York County Municipal Government, Maine

REQUEST FOR PROPOSAL (RFP) # YC-*2026-4681393*

HVAC System Upgrade- Courthouse Condenser Units

ADDENDUM NUMBER 1

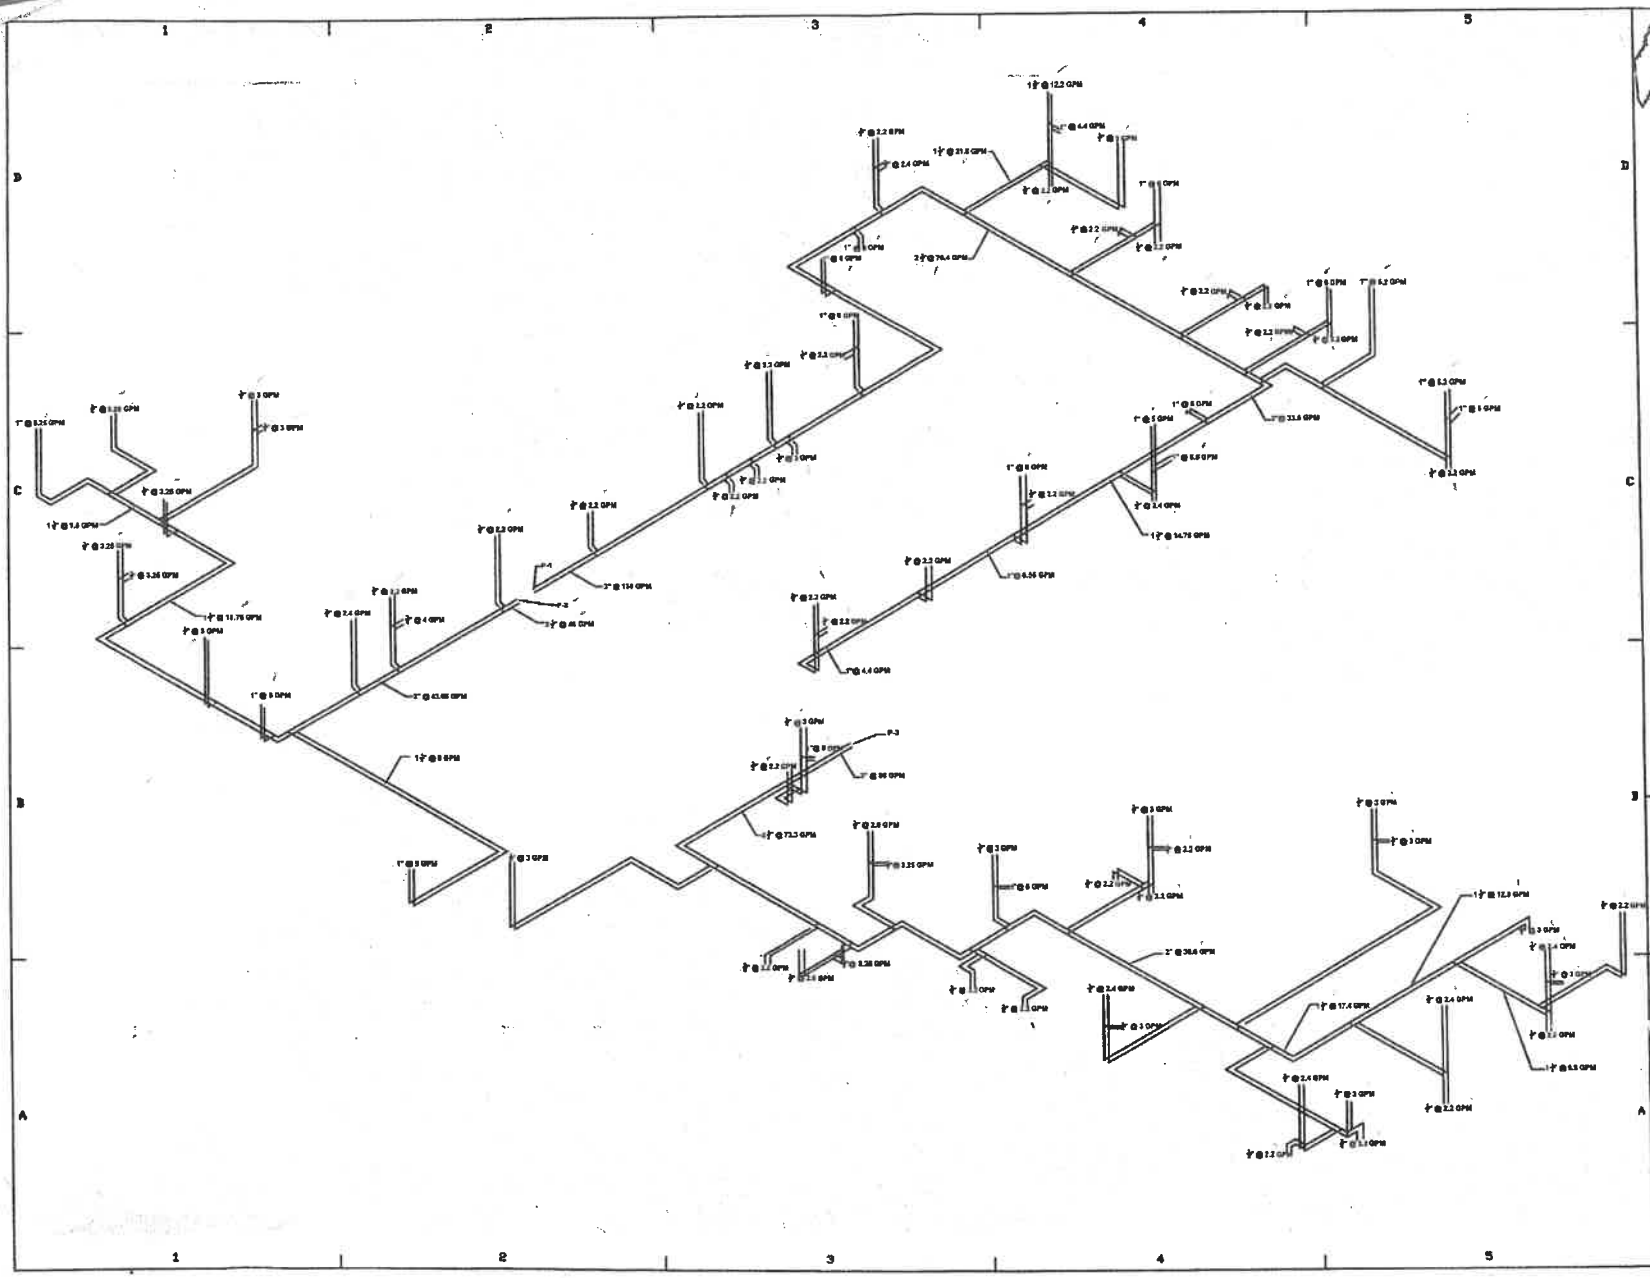
2) "Available drawings, as-builts, and piping/control schematics for the wells, well pumps, and associated equipment, showing the groundwater supply and discharge/return arrangement?"

Answer: Please see the attached documentation.
